ARCHITECTURAL REVIEW BOARD STAFF REPORT

Project #/Name	ARB-2020-1: Our Neighborhood Child Development Center Initial Site Plan
Review Type	Initial Site Development Plan
Parcel Identification	078000000058K0
Location	1395 Stony Point Road (Route 20) (Figures 1 & 3)
Zoned	Residential (R1)/Entrance Corridor (EC)/ Flood Hazard Overlay District/Dam Inundation Zone
Owner/Applicant	James A. Jr. or Peggy W. Dettor/Shimp Engineering (Justin Shimp)
Magisterial District	Rivanna
Proposal	To renovate two existing structures, totaling approximately 6,700sf, to accommodate a child daycare center with a parking lot expansion and associated site improvements on approximately 3.607 acres.
Context	There is a mix of development along this portion of Stony Point Road, with the Riverside Village mixed-use development directly across the street, the Wilton Farm residential development behind (northeast of) the parcel, and commercial uses to the south on both sides of the road (Figure 2). The majority of the commercial buildings in the vicinity have been reviewed and approved by the ARB, but there are some buildings to the south that predate the establishment of the EC and, consequently, may not meet the

Figure 5: Existing trees and shrubs not shown in site plan (picture left - trees and shrubs in the middle) & existing evergreen screening not shown in site plan (on right).

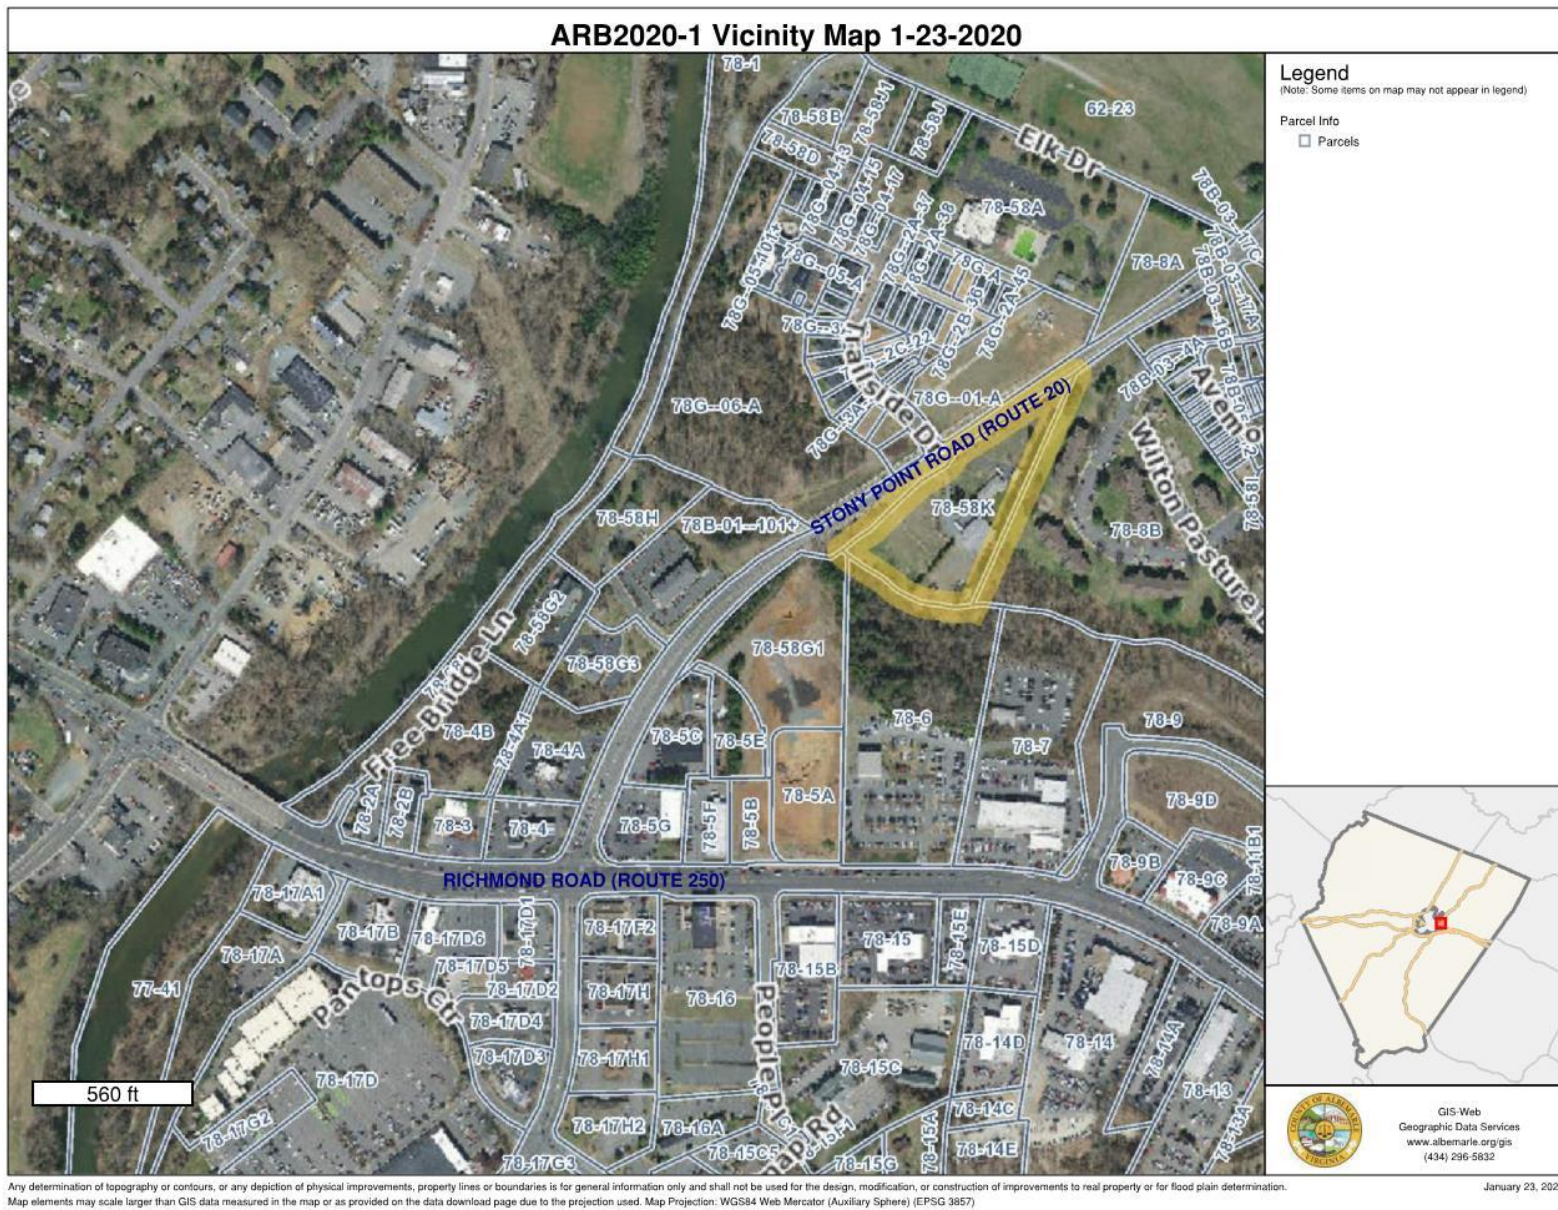
f. The placement of structures on the site should respect existing views and vistas on and around the site.		
40	Site grading should maintain the basic relationship of the site to surrounding conditions by limiting the use of retaining walls and by shaping the terrain through the use of smooth, rounded land forms that blend with the existing terrain. Steep cut or fill sections are generally unacceptable. Proposed contours on the grading plan shall be rounded with a ten foot minimum radius where they meet the adjacent condition. Final grading should achieve a natural, rather than engineered, appearance. Retaining walls 6 feet in height and taller, when necessary, shall be terraced and planted to blend with the landscape.		
41	No grading, trenching, or tunneling should occur within the drip line of any trees or other existing features designated for preservation in the final Certificate of Appropriateness. Adequate tree protection fencing should be shown on, and coordinated throughout, the grading, landscaping and erosion and sediment control plans.	There is existing landscaping on the site that is not shown on the site plan (Figures 4 & 5).	Ensure all existing landscaping is shown on the site plan.

42	Areas designated for preservation in the final Certificate of Appropriateness should be clearly delineated and protected on the site prior to any grading activity on the site. This protection should remain in place until completion of the development of the site.	There are existing trees that are not shown on the site plan. Evergreen trees along the western edge of the parking area in the southeast corner of the parcel (Figure 5) could be impacted by the removal of a portion of the parking area surface. Two large existing trees on the northern edge of the improved accessway could be impacted by the expansion of the accessway and parking area.	Show tree protection fencing for preserved trees in both the grading and landscape plans.
43	Preservation areas should be protected from storage or movement of heavy equipment within this area.	No tree protection fencing is shown on, and no conservation checklist is included in, the site plan.	Provide a conservation checklist in the site plan.

13. Add the standard plant health note to the landscape plan.
14. Ensure all existing landscaping is shown on the site plan.
15. Show tree protection fencing for preserved trees in both the grading and landscape plans.
16. Provide a conservation checklist in the site plan.
17. Ensure that no grading is proposed within the dripline of any tree designated as preserved.
18. Sign applications are required for all proposed signs.
